Access Compliance Report Public Rights-of-Way (Pedestrian Signals)

Main Street: **W_ORANGE_AVE** Cross Street: **GILBERT_ST** Location: **NW**

ADA ID: **SGRK210927110031** Signal Type: **One Push Button-Non APS** Overall Compliance: **No** Severity Scores: **BTN 1: 25** **BTN 2: N/A** **No BTN: N/A**

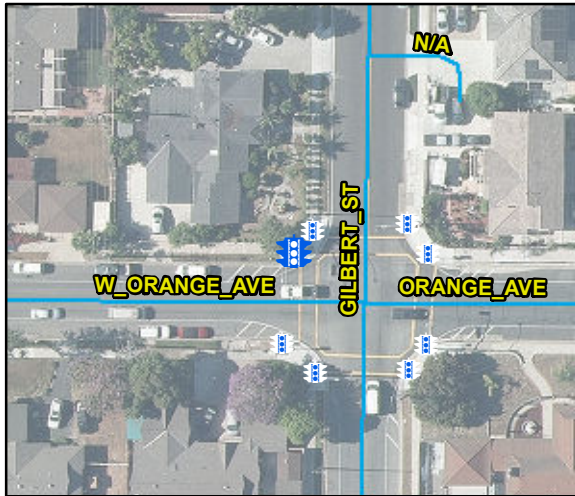
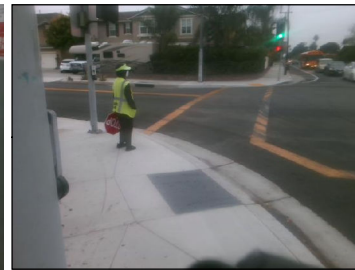
OC Std/PROW: **R404.2, R404.3**

Possible Solutions: Remove and Replace Clear Space.
